Access Compliance Report

Public Rights-of-Way

(Curb Ramps)

Intersection ID: 54470	Main Street: PETE_BROWN_RD	Cross Street: FOX_POINT_DR	Location: SW
ADA ID: 0690CF90AFC0	Ramp Type: Directional	Initial Pass/Fail: Fail	Overall Compliance: No
			Severity Score: 13.75

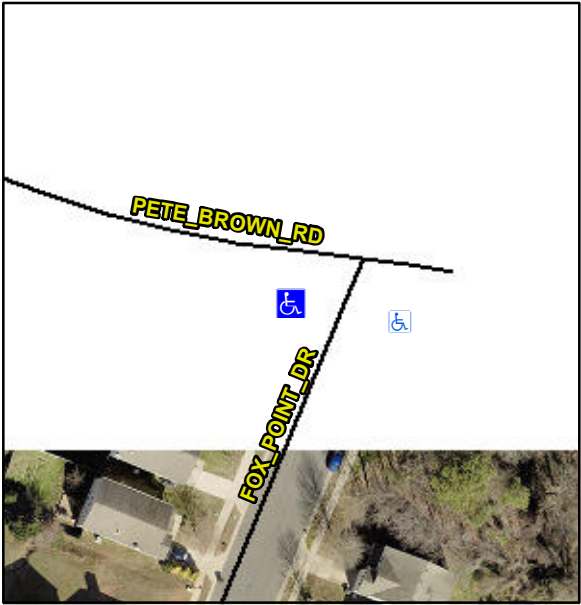
Codes/Mitigation Info/Possible Solution		Field Measurements/Component Compliance					
 <p>Street 1 Name: FOX POINT DR</p> <p>Stop Condition-Street 1: StopSign</p> <p>Street 2 Name: N/A</p> <p>Stop Condition-Street 2: N/A</p>	Possible Solutions:	Compliance	Description	Data	Compliance	Description	Data
	Remove & Replace Entire Ramp.	N/A	Ramp Length (in)	36.0	N/A	Grade Break?	N/A
		Yes	Ramp Width (in)	71.5	N/A	Grade Break Slope (%)	0.0
		No	Ramp Slope (%)	8.7	N/A	Grade Break XSlope (%)	0.0
		No	Ramp XSlope (%)	2.2			
		N/A	Flare Type LT	N/A	N/A	Flare Type RT	N/A
		N/A	Flare Slope LT (%)	N/A	N/A	Flare Slope RT (%)	0.0
		N/A	Flare Traversable LT?	N/A	N/A	Flare Traversable RT?	N/A
		N/A	Landing Length (in)	0.0	N/A	DWS Provided?	N/A
		N/A	Landing Width (in)	0.0	N/A	DWS Contrast?	N/A
		N/A	Landing Slope (%)	0.0	N/A	DWS Length (in)	N/A
		N/A	Landing X Slope (%)	0.0	N/A	DWS Full Width?	N/A
		N/A	Landing Curb? (Y/N)	N/A	N/A	DWS Offset LT (in)	N/A

N/A	Shared Landing?	N/A	N/A	DWS Offset RT (in)	N/A
		N/A	Gutter Ponding?	0.0	N/A	Gutter Slope (%)	N/A
		N/A	Gutter Lip Ht (in)	0.0	N/A	Gutter X Slope (%)	N/A
		N/A	Painted X Walk1?	No		Road Slope (%)	1.6
			X Walk 1 Direction	To NE		Road X Slope (%)	4.4
			X Walk 1 Width (in)	N/A		Clear Space?	N/A
			X Walk 1 Slope (%)	1.6	N/A	Clear Space to XWalk (in)	N/A
			X Walk 1 X Slope (%)	4.4	N/A	Storm Grate/Utility Hazard?	N/A
		N/A	Ramp inside XWalk1?	N/A		Storm Grate/Utility Type	
		N/A	Any Obstructions?	N/A			N/A
			Obstruction Type		Yes	Surface Condition? (G/P)	Good
					N/A	Curb Slope (%)	N/A
Total Cost:		\$	1600.00
